ORIGINATION FORM

Proposed Revisions to a Standard Plans Index
(Please provide all information — Incomplete forms will be returned)

CONDUIT DETAILS - EMBEDDED

INDEX
630-010

INDEX	SHEET
630-010	1 of 4

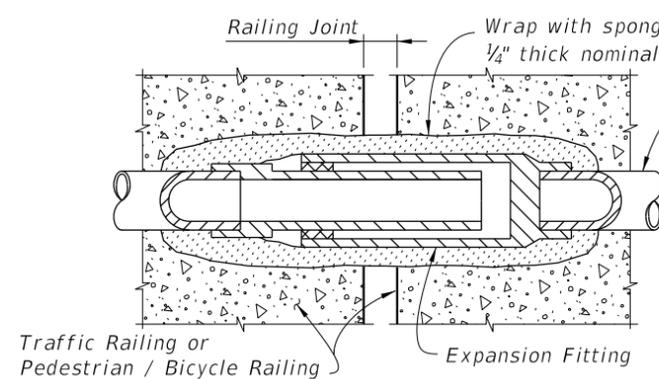
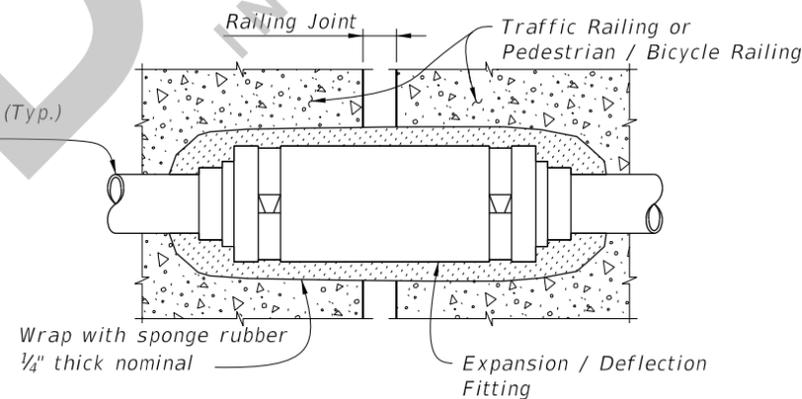
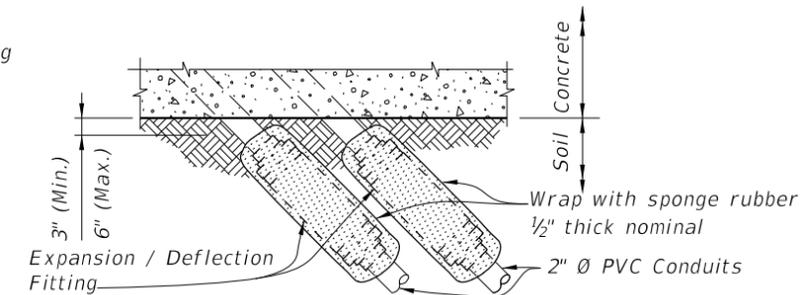
5. Place conduits as indicated in this Standard unless the General Notes in the Structures Plans indicate fewer.
